Re: License STC-133, Docket No. 04000341, Control No. 137882

SUBJECT: Defense Logistics Agency, Request for Additional Information Concerning
Application for Amendment to License

**DLA RESPONSE TO NRC RAI
ATTACHMENT 1**

Topography Map of Somerville Depot

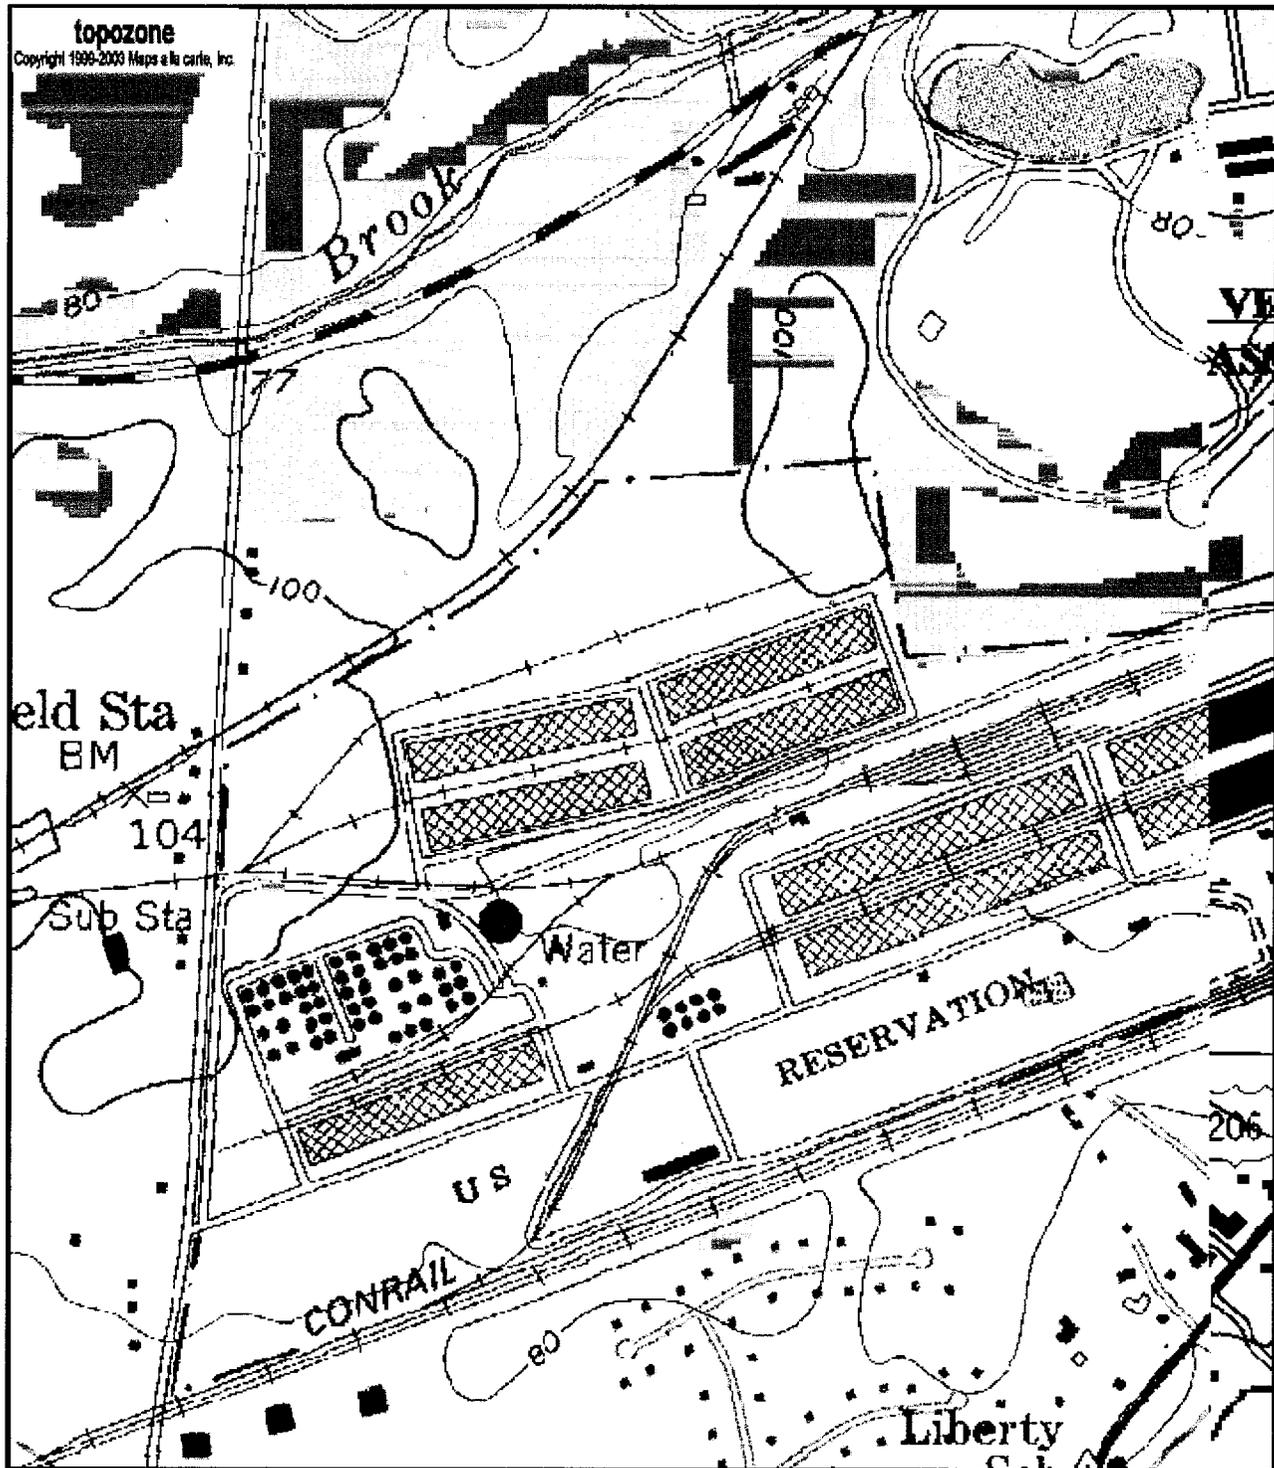
RAI # 2(b) A map that shows the detailed topography of the site using a contour interval (16.3.1)

Response to RAI # 2(b) A detailed topography map is included as Attachment 3 for the Somerville site which shows that the land level does not substantially change at the site. The map shows a 90' contour line extending nearly the entire distance along Warehouses 2 and 3. The topographic map is a USGS from the "TopoZone" and is on the smallest usable scale available:
